Certificate of Appropriateness

2451 - 57 N. TERRACE AV. & 2727 – 29 BRADFORD AV
NORTH POINT NORTH HISTORIC DISTRICT

114465 COA: landscaping, driveway, fences, & dormer

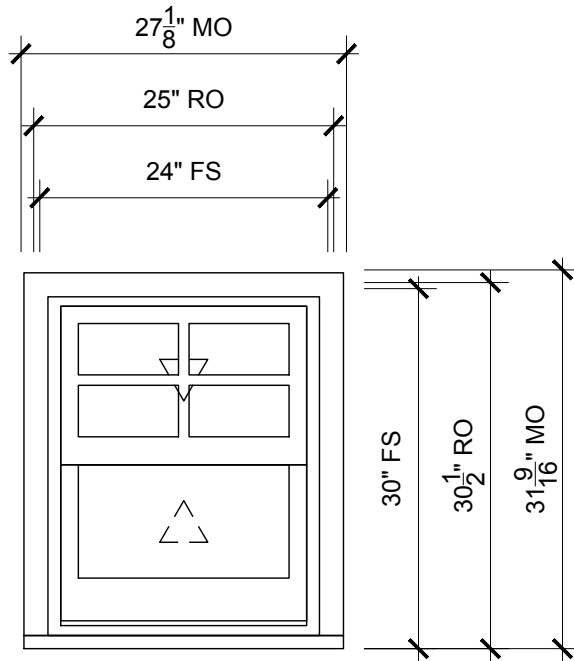
Fence for property line, must be painted or treated with an opaque stain.

Terrace Avenue View showing skylight to be replaced with dormer.

Powder-coated aluminum fence.

- A. Fence shall be painted or treated with an opaque stain.
- B. Approval of the dormer on the street-facing elevation is specific to unique conditions at this property documented in the staff report of CCF 171797 and adopted by the Commission.

DRAWING NO:
A104

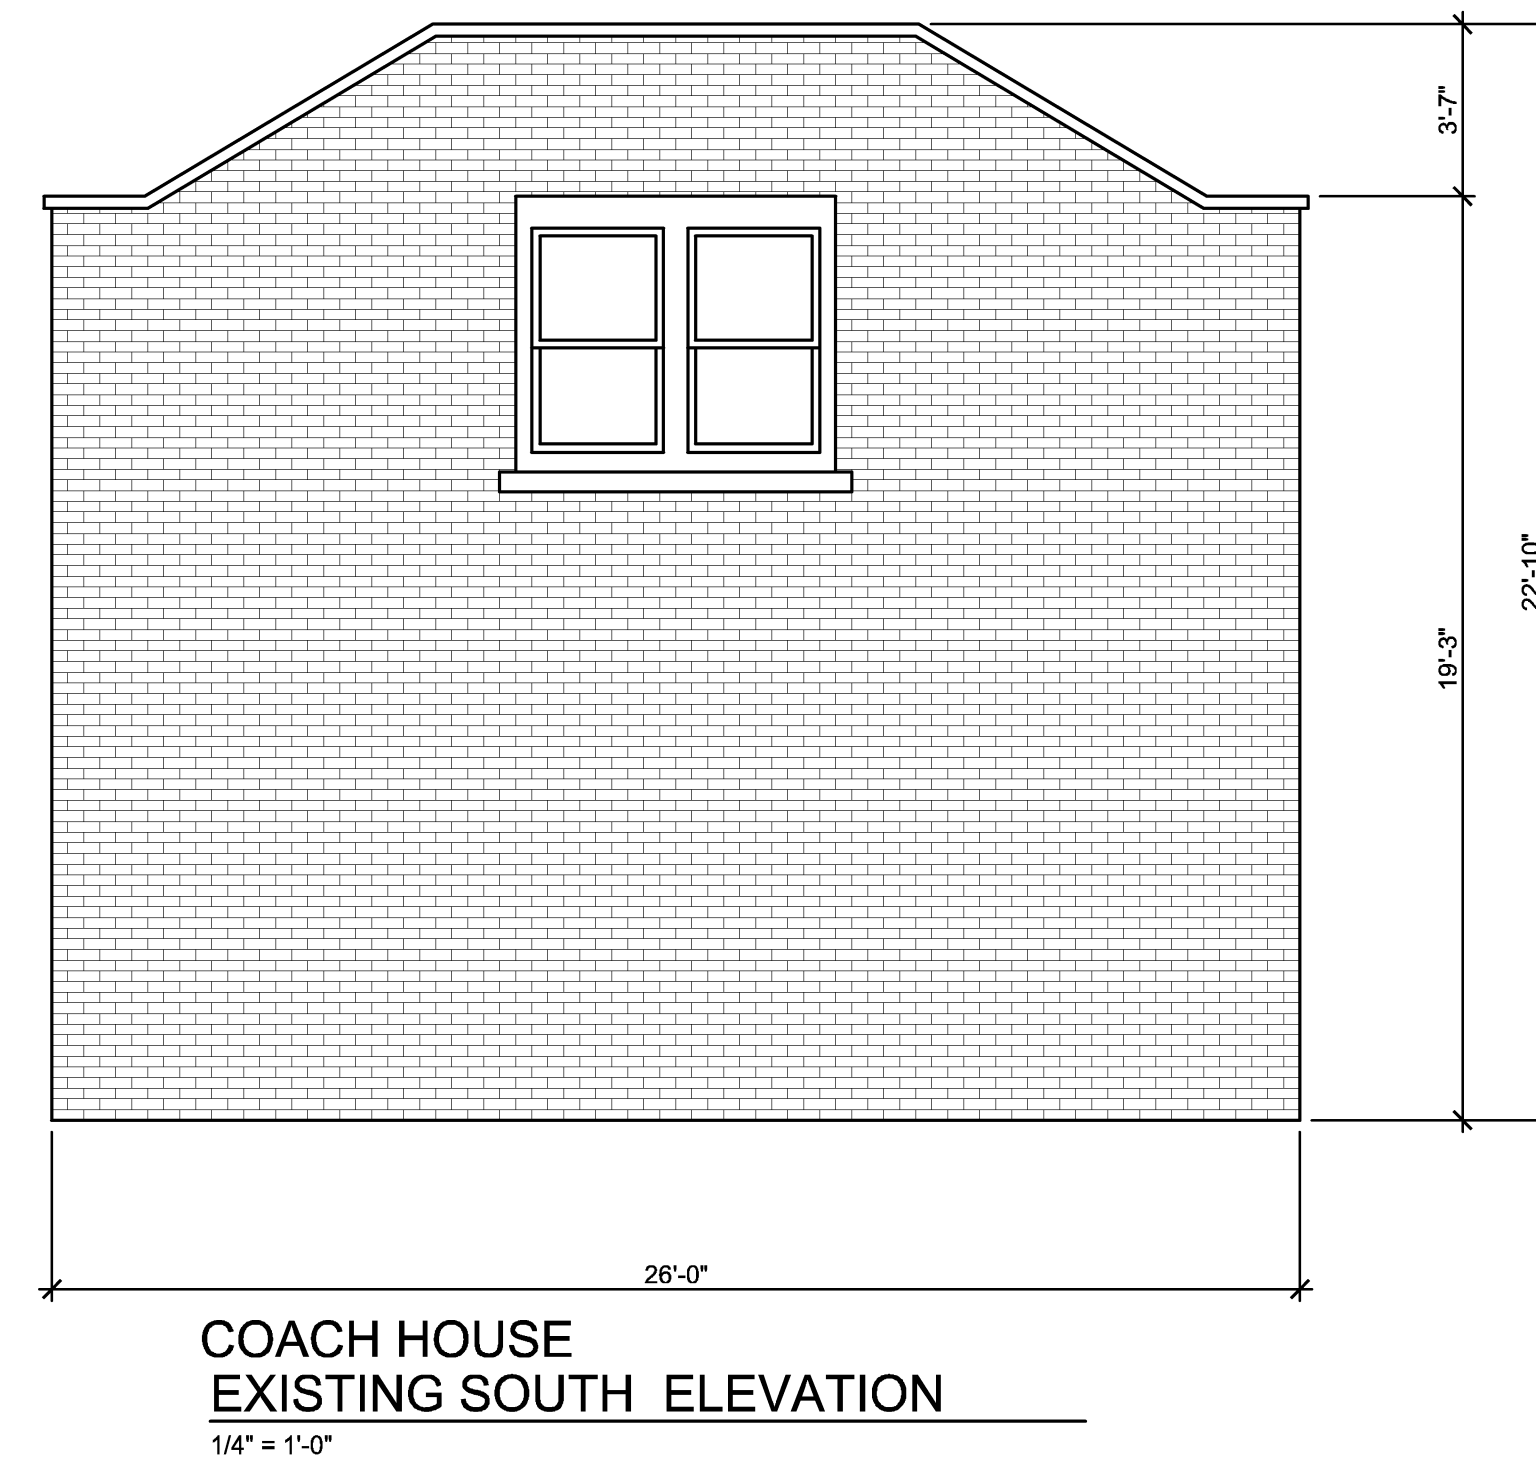
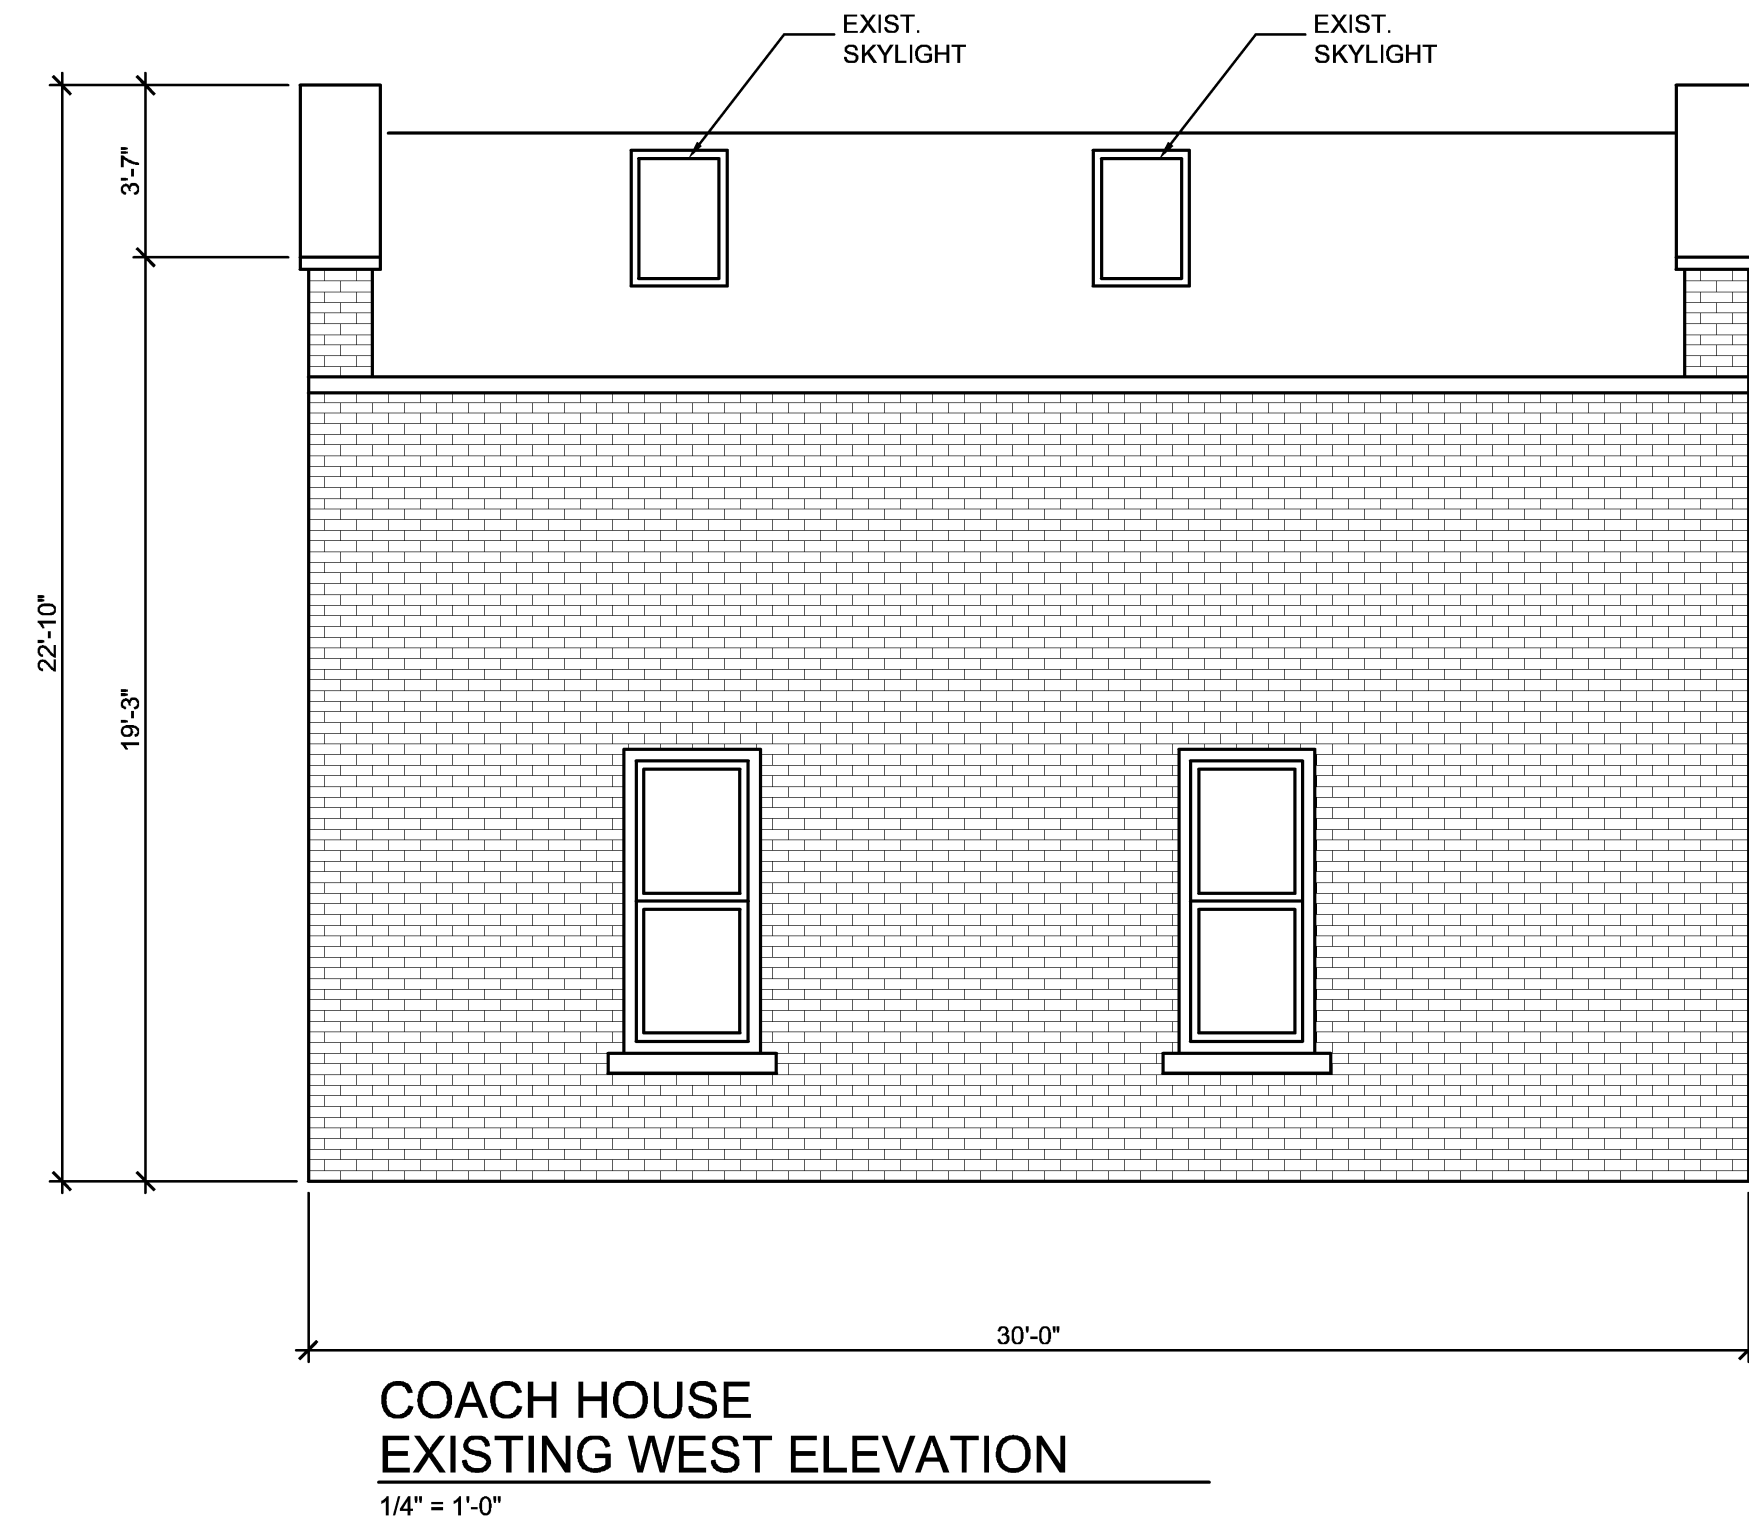
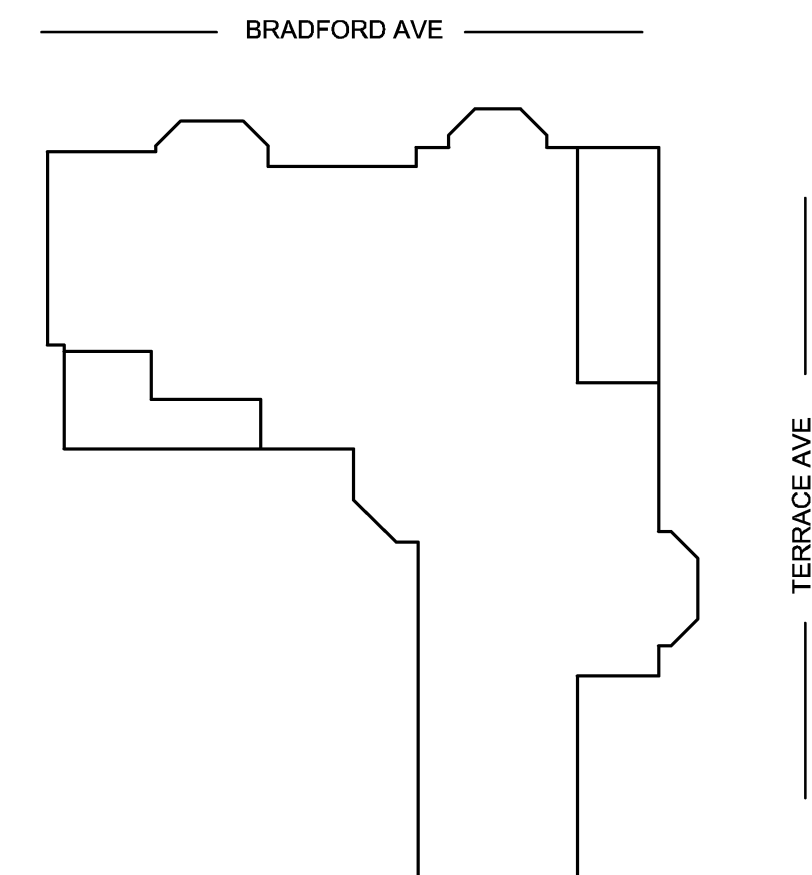
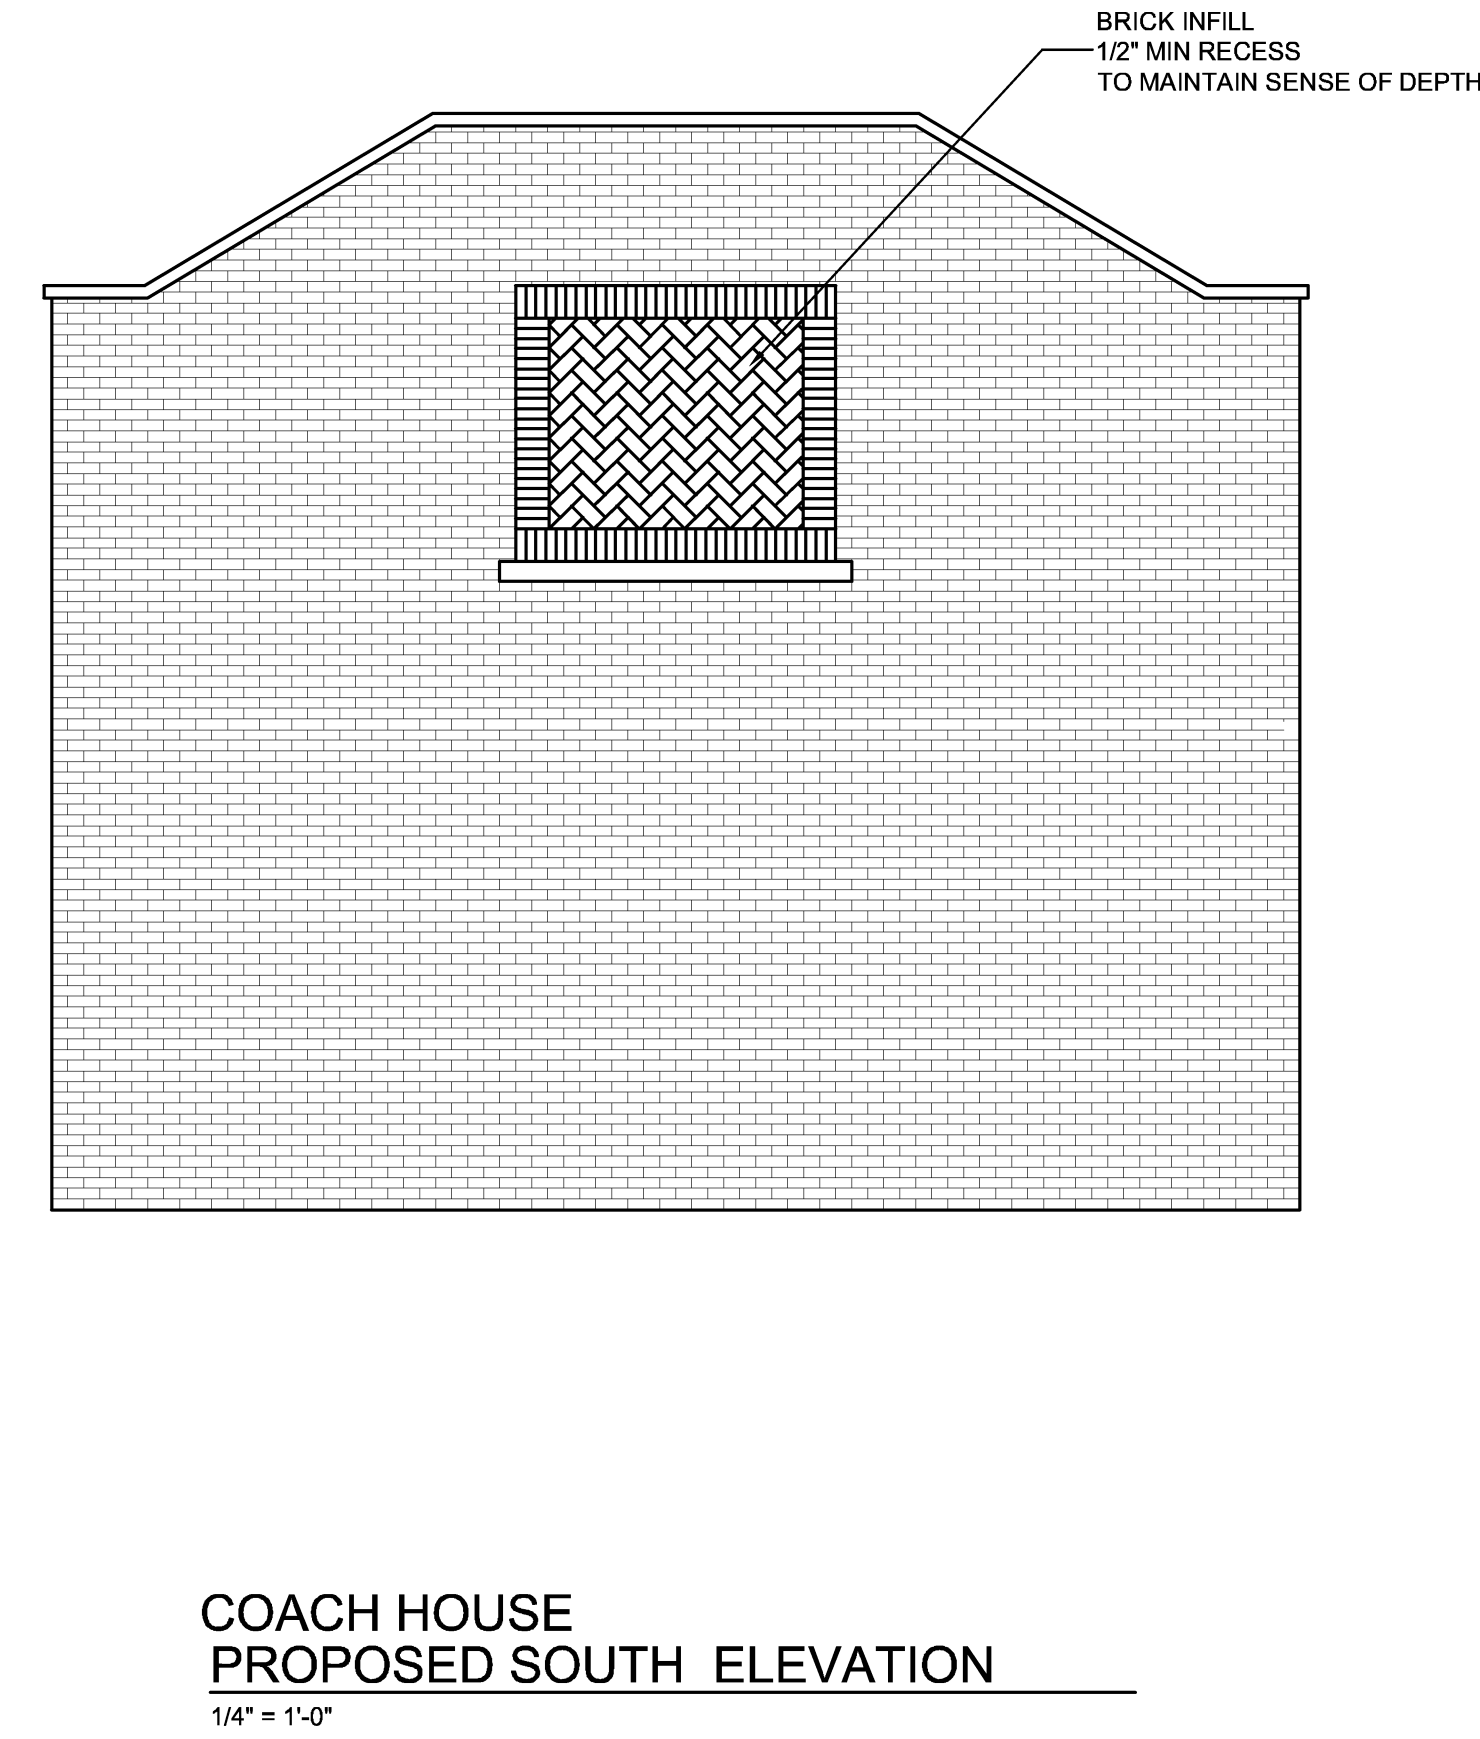
Remodel two courtyard sides of Coach House new fenestration and repairs to masonry. Remaining 2 sides of coach house are located 6" from the property line, therefore no combustible materials will be used on these walls, existing brick to remain. Enclose with brick panels that are recessed 1/2" from main wall (Pages A104 and A105).

- C. **Standard Masonry conditions:** New mortar must match the original mortar in terms of color, texture, grain size, joint width, and joint finish/profile. The compressive strength of the repointing mortar shall be equal or less than the compressive strength of the original mortar and surrounding brick or stone. The replacement mortar shall contain approximately the same ingredient proportions of the original mortar. Mortar that is too hard is subject to premature failure and could damage the masonry. In most cases, this means a lime mortar with natural hydraulic cement rather than Portland cement. No joint of a width less than 3/8" may be cleaned of damaged/decomposed mortar with power disc grinders. No over-cutting of the joints is permitted. Remove decomposed mortar back into the wall 2.5 times the height of the joint before tuckpointing.
New brick must match as closely as possible the color texture, size, and finish of the original brick. A sample panel of brick and mortar must be reviewed and approved by HPC staff prior to general installation of the material.
